# C620 – Signalling Area 5 Scheme Plan

**CRL Document Number: C620-SIC-R2-DWG-CR001-50050**

Sheet Number/Reference	Rev.	Sheet Title
SJ58/GEN/M/059	N/A	Modification Front Sheet.
C620-SIC-R2-DDE-CR001-00004	EF	Signalling Scheme Plan – Area 5; Stratford.
SJ58/GEN/M/062	N/A	Modification Front Sheet.
C620-SIC-R2-DDE-CR001-00004	EG	Signalling Scheme Plan – Area 5; Stratford.

Drawing No: C620-SIC-R2-GDE-CR001-00004 Rev: EG EFF

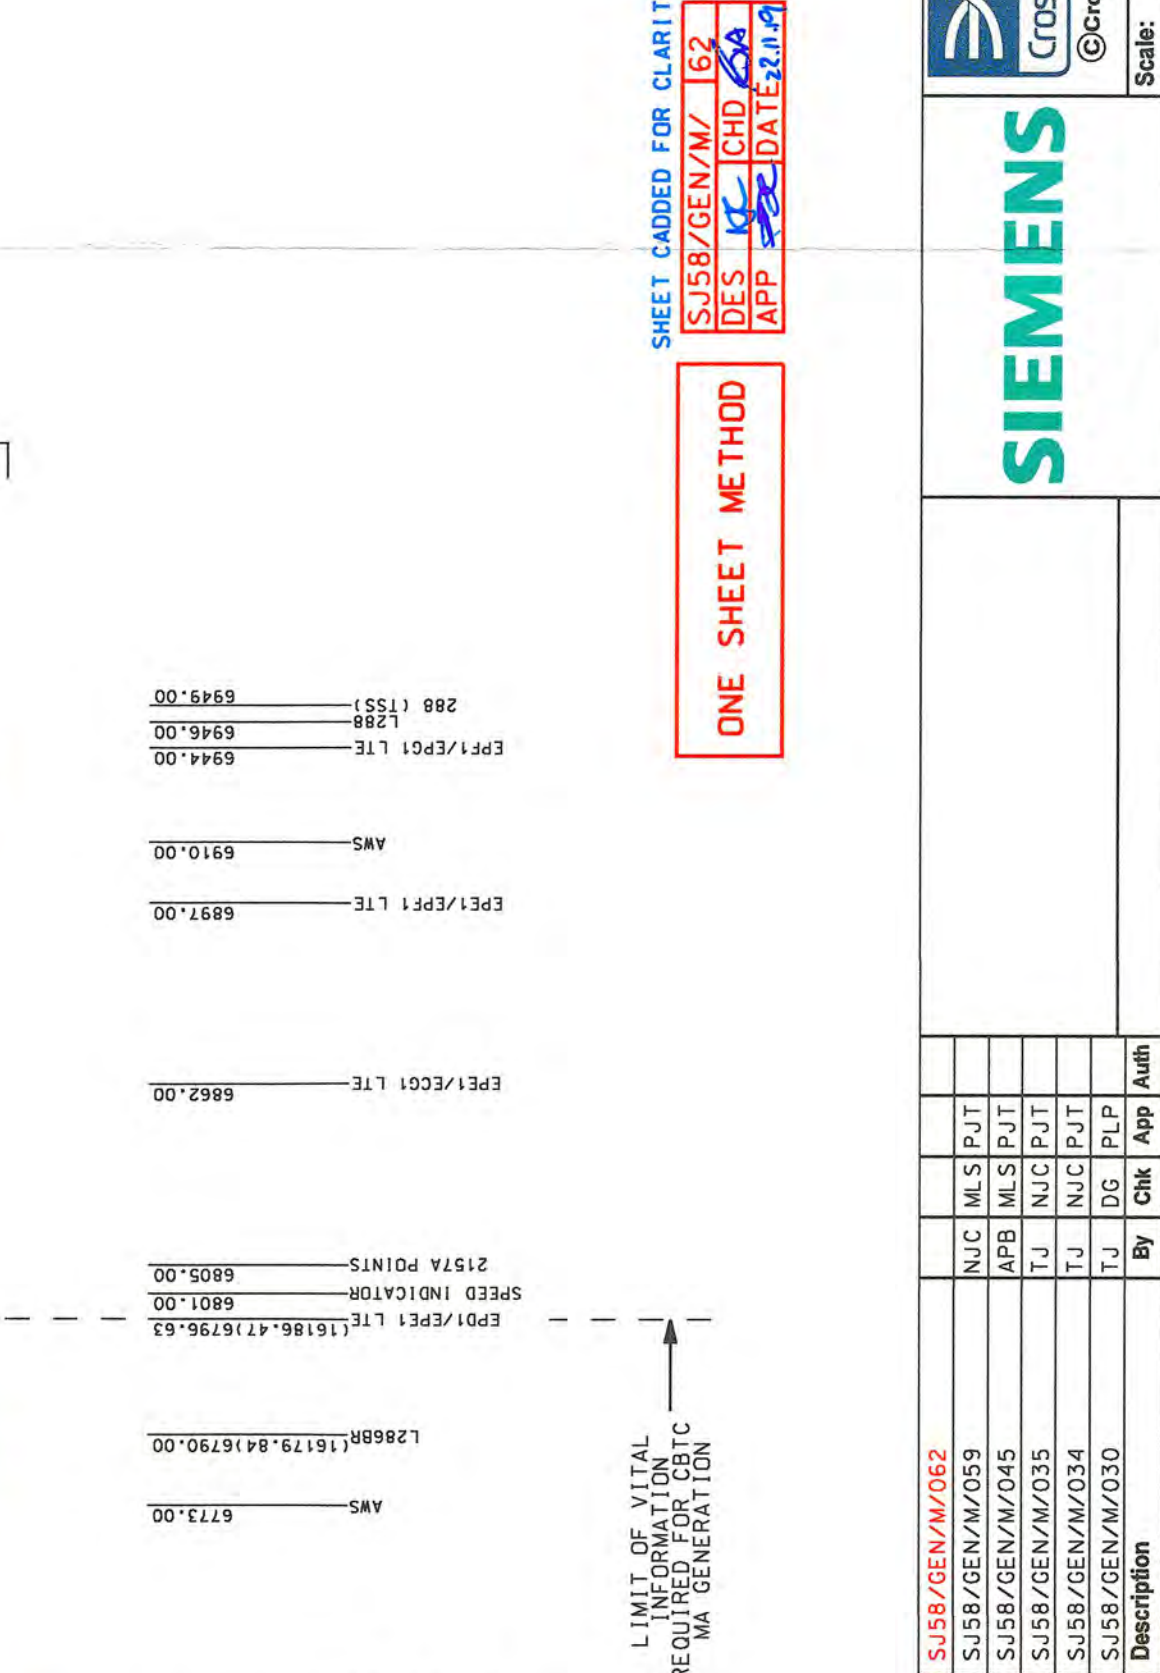
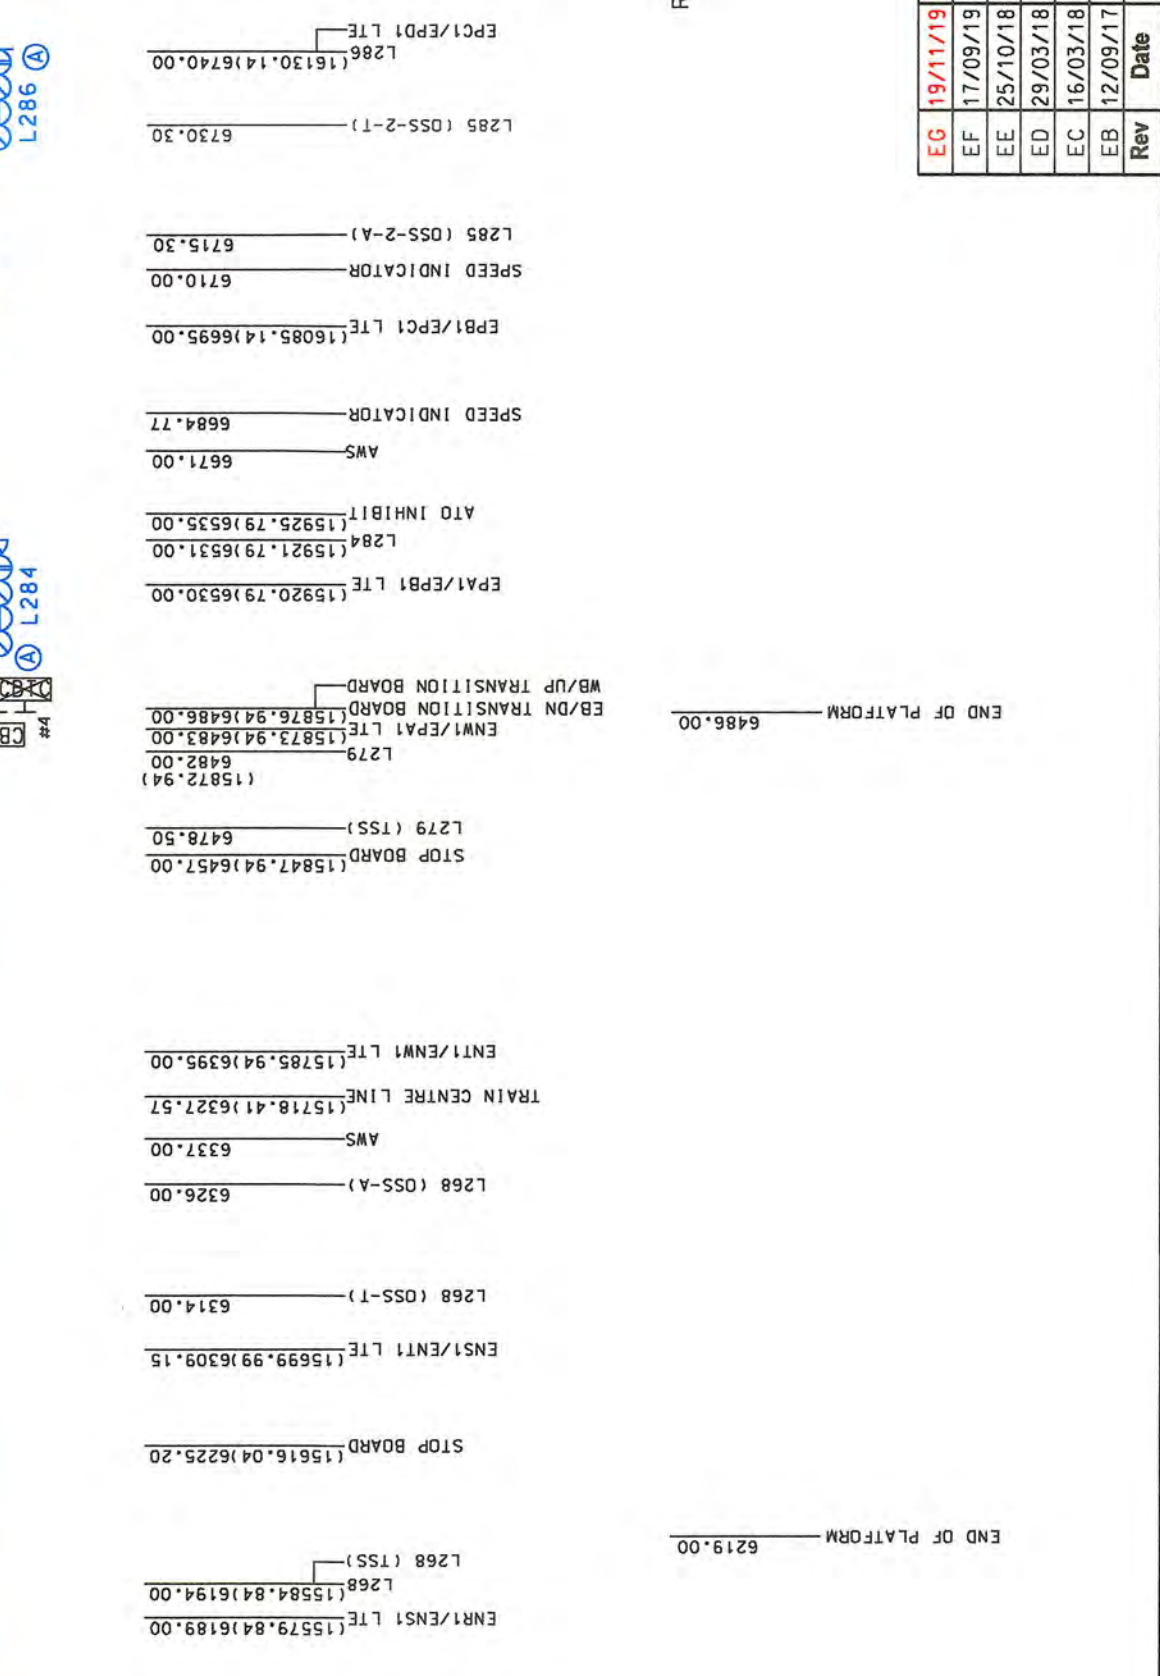
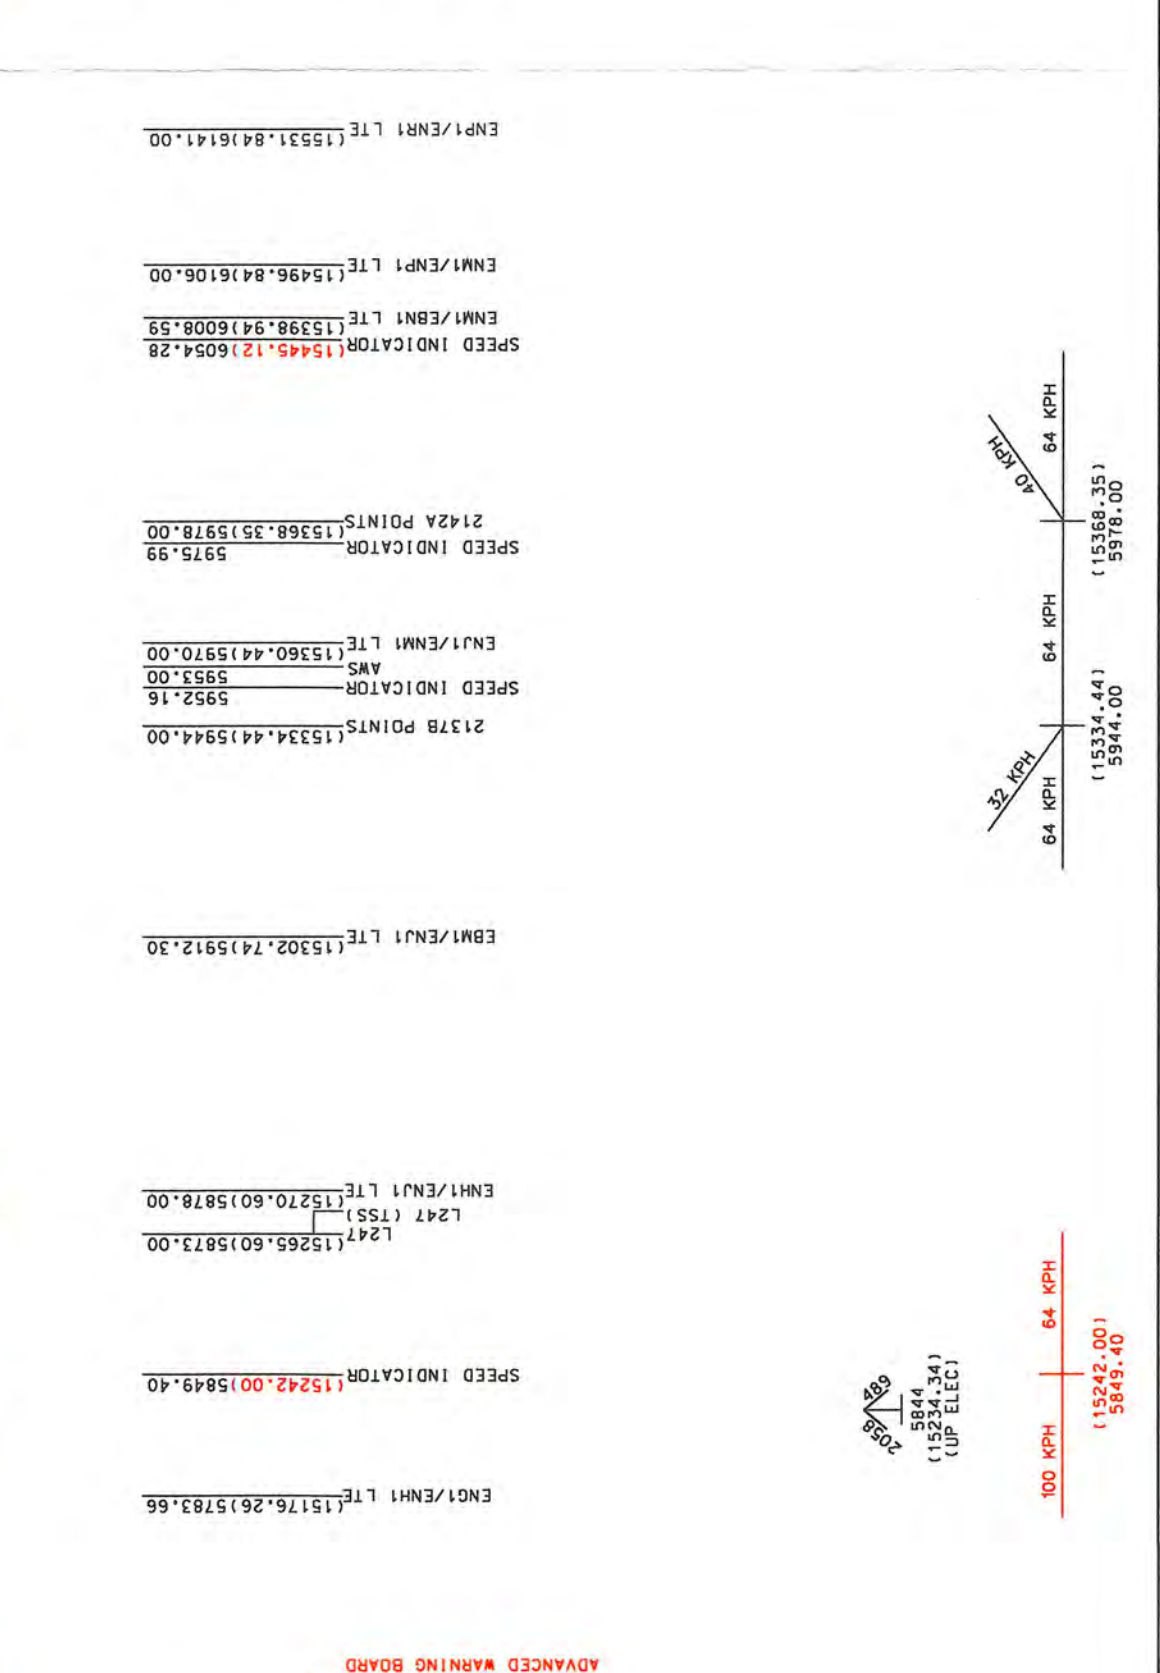
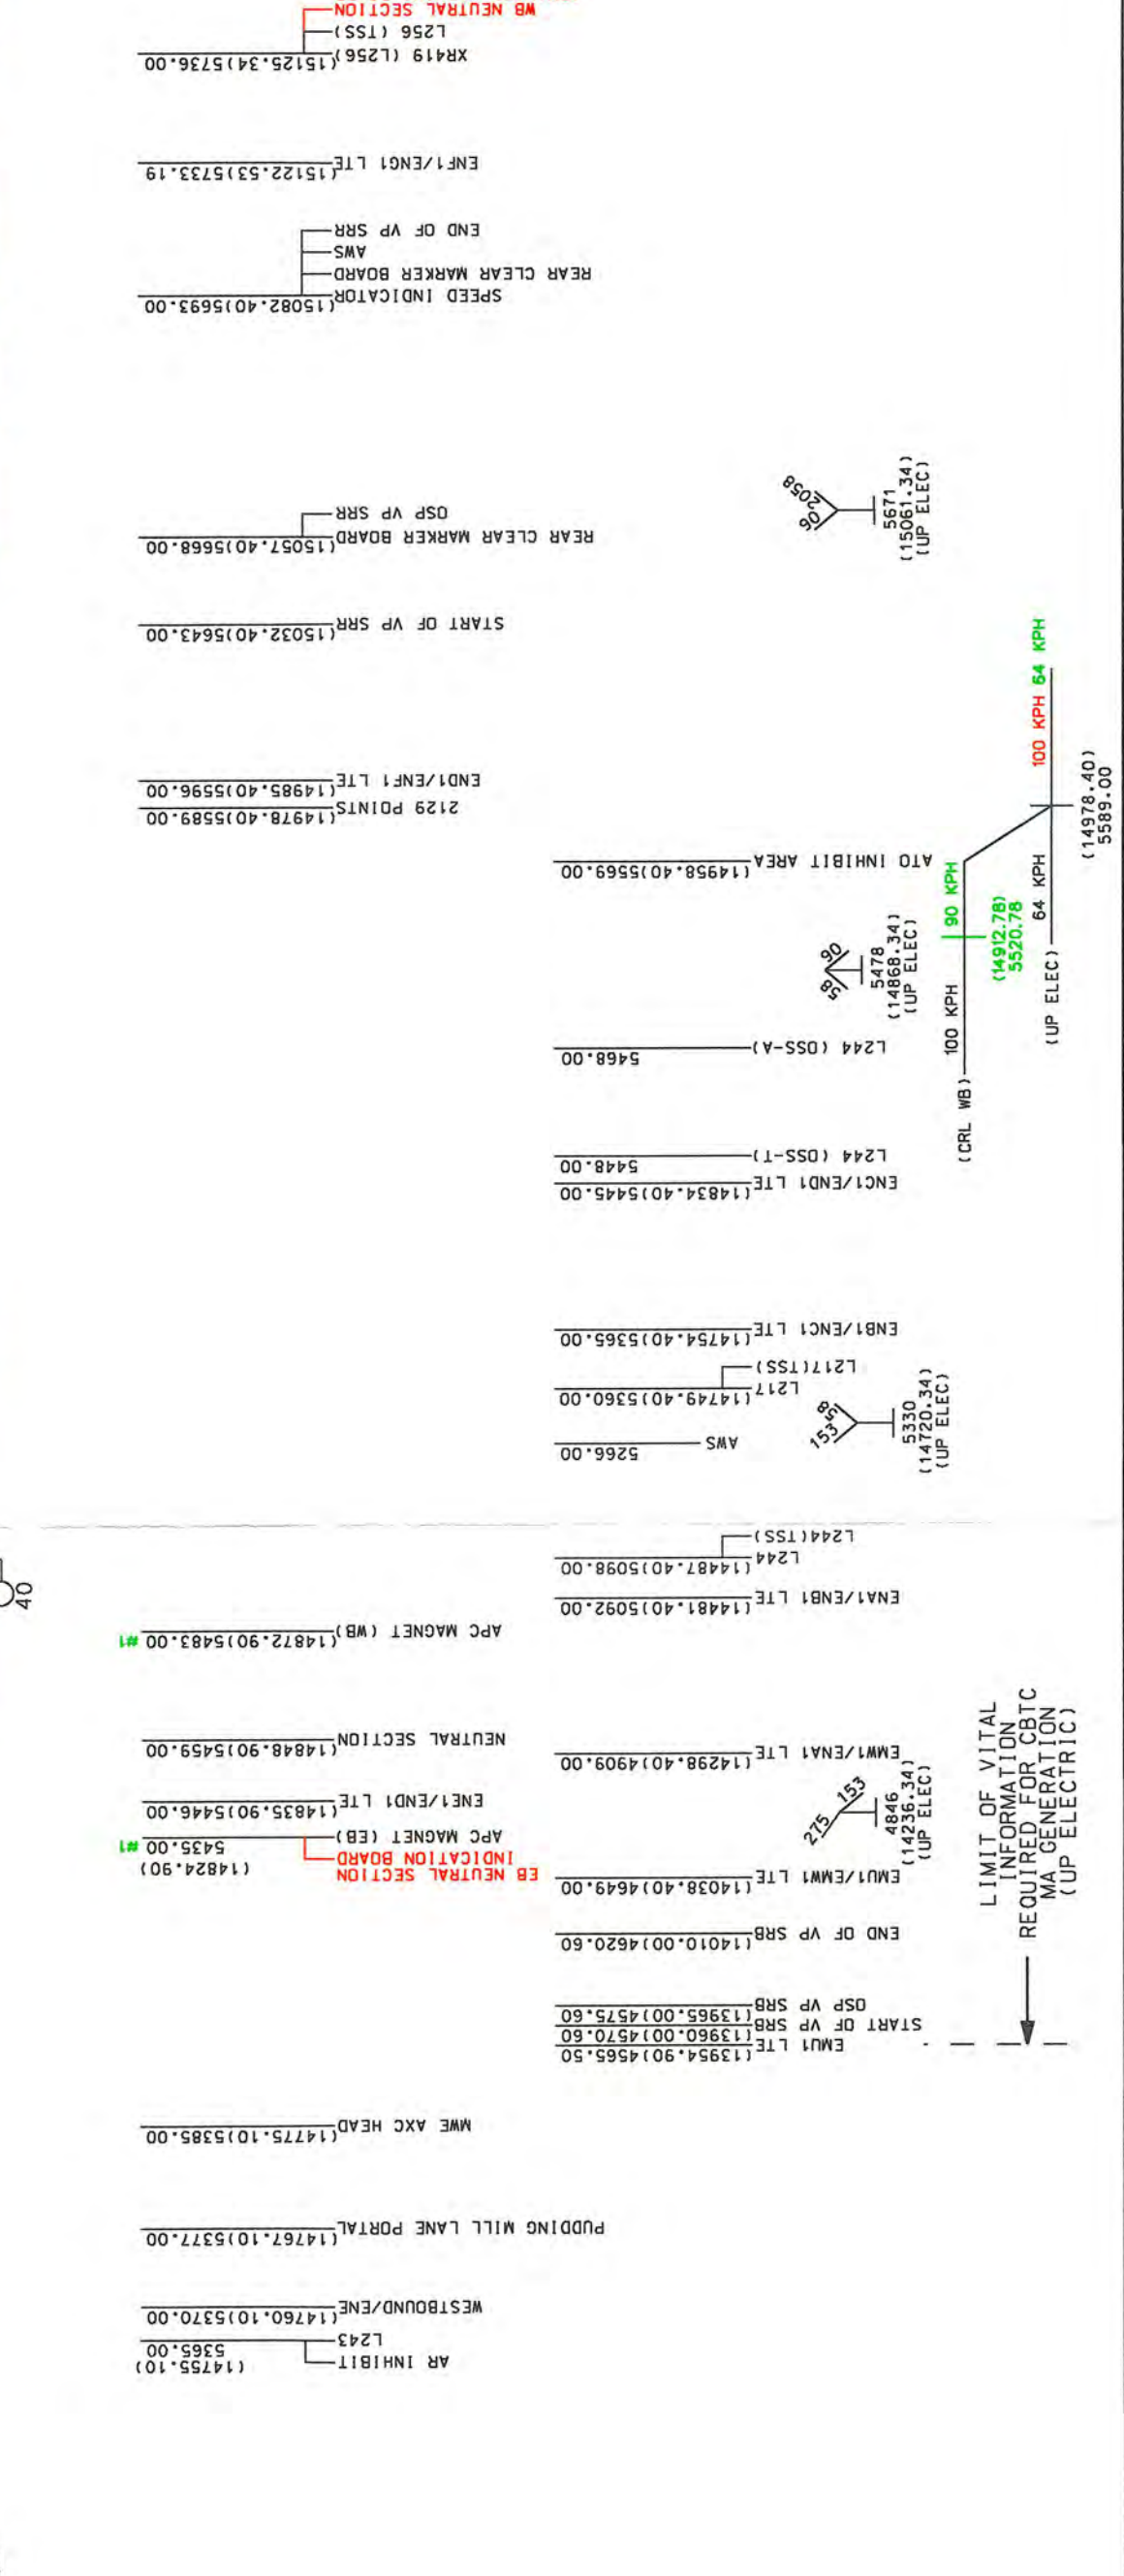
Reference Documents used for this design:		
Previous update reference:	SJ58/GEN/M/059	
Doc. Number	Document Title	Document Version
APC2	Sighting Form – Neutral Section Indication East on Westbound	6
APC4	Sighting Form – Neutral Section Indication West on Eastbound	6
W419	Sighting Form – Neutral Section Advanced Warning West on Up Electric	6
PMI-0445	GEML Overlay Section all CBTC fitted trains Lines Speeds inputs	-
NOTE:	CHANGES NOT IN P-D+11.

DESIGN DECISIONS: Use this section to record calculations and other factors relevant to making design decisions.		
ITEM No.	DETAILS	REMARKS
1.	No items transferred from previous modification SJ58/GEN/M/059	
2.	Sighting Forms W419 & W421 document the position of the same Neutral Section Advanced Warning board. W419 used for dimensioning.	
3.	Items 5a & 5b detail overlapping directional based line speeds (to/from COS). As the TGMT system can only cater for one line speed over a given area, the most restrictive speed has been selected where differing speeds overlap.	
4.		
5.		
6.
